"OLD" Composite Out mod

Sheet: /CGA 5/6/
File: CGA_5_6.kicad_sch

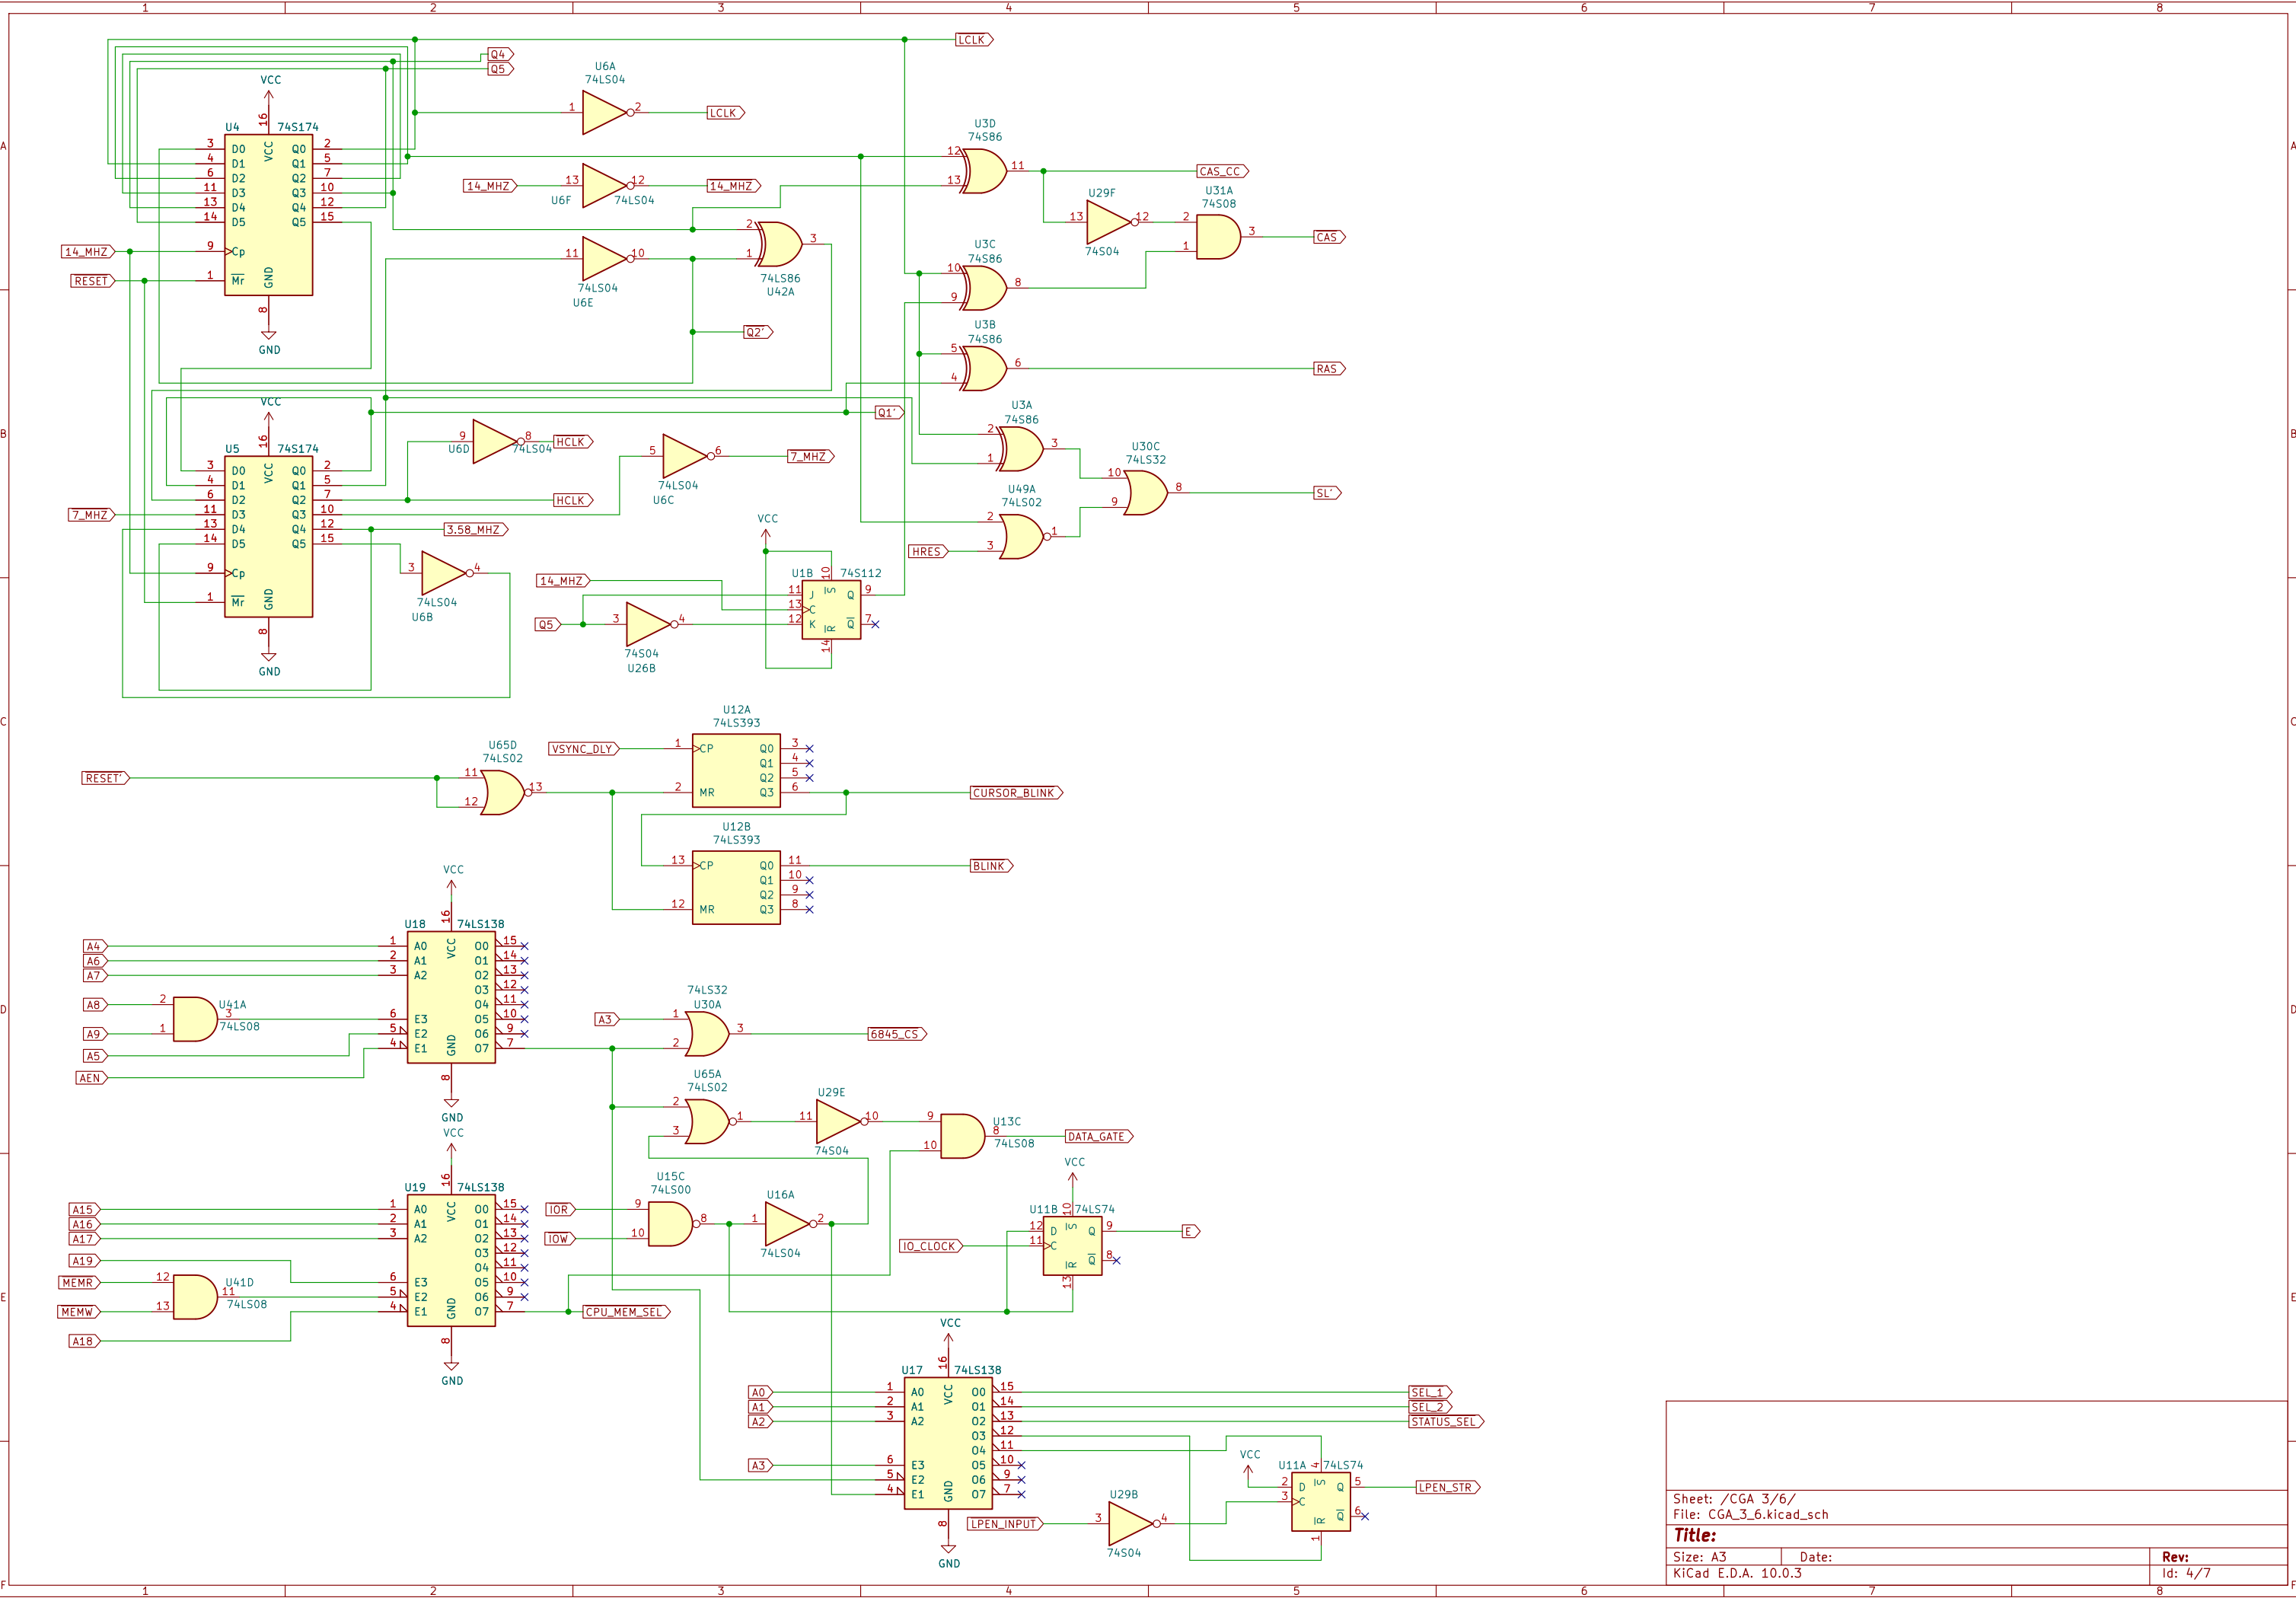
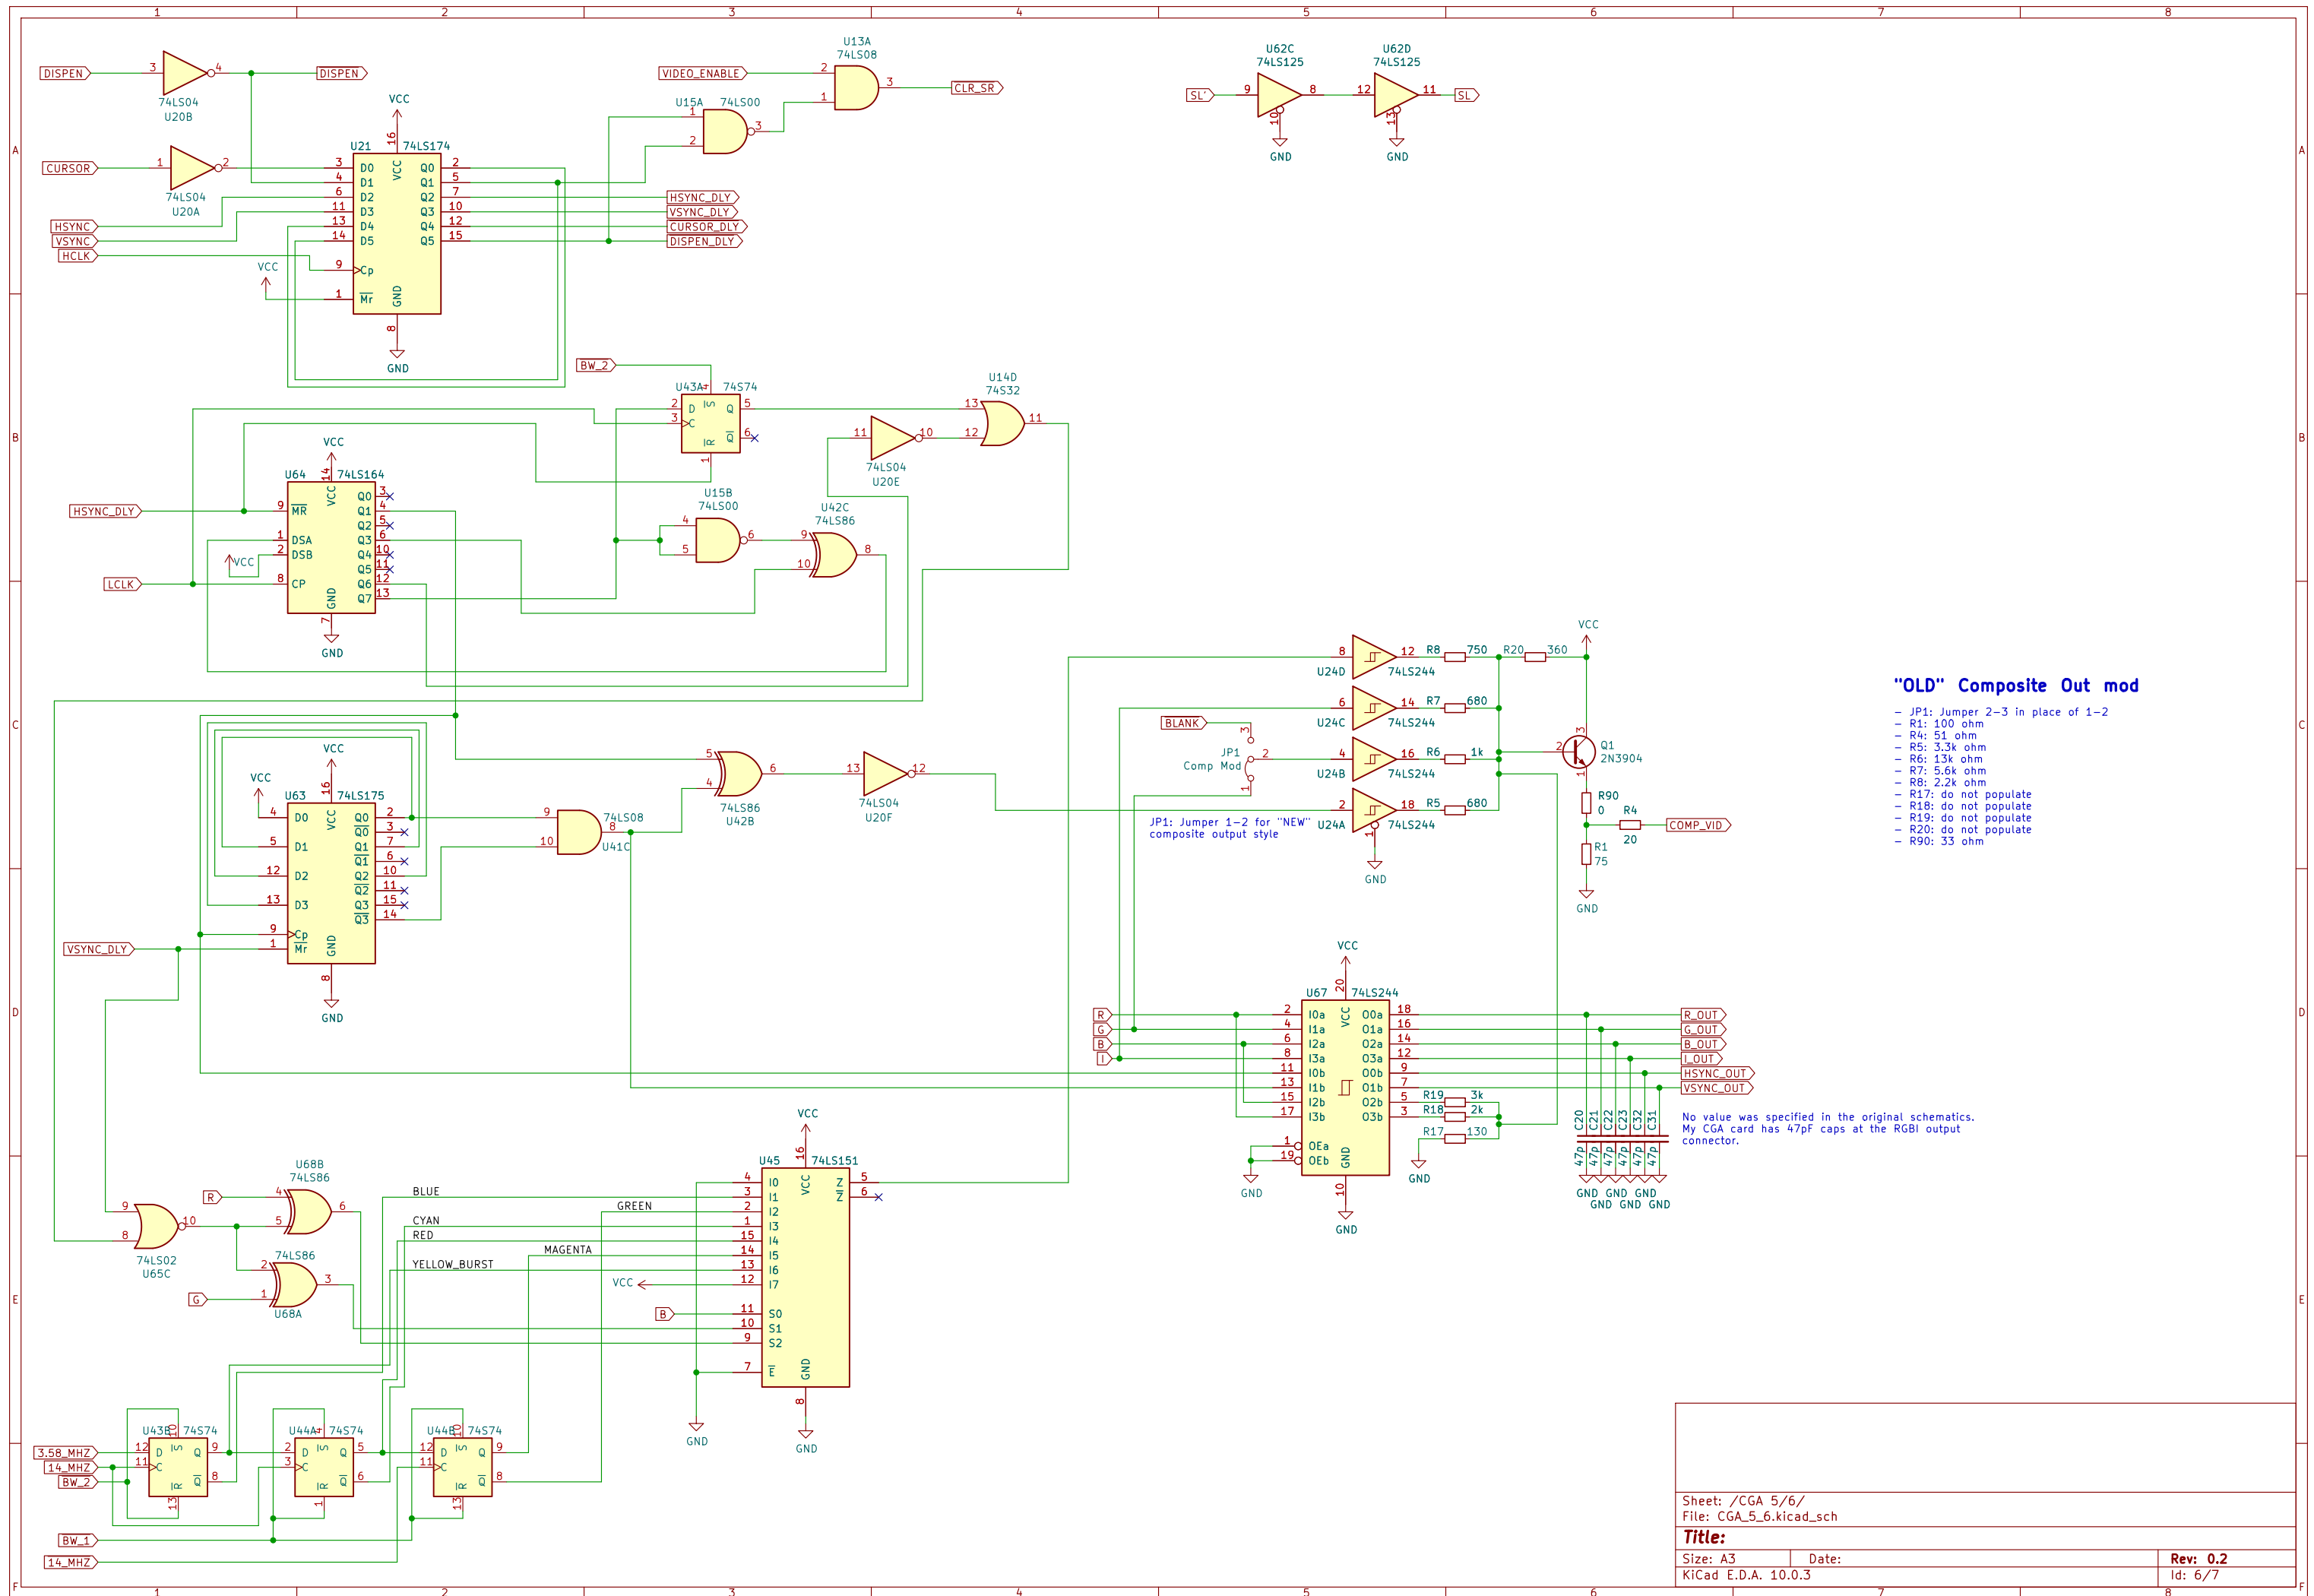
- JP1: Jumper 2-3 in place of 1-2
- R1: 100 ohm
- R4: 51 ohm
- R5: 3.3k ohm
- R6: 13k ohm
- R7: 5.6k ohm
- R8: 2.2k ohm
- R17: do not populate
- R18: do not populate
- R19: do not populate
- R20: do not populate
- R90: 33 ohm

No value was specified in the original schematics.
My CGA card has 47pF caps at the RGBI output connector.
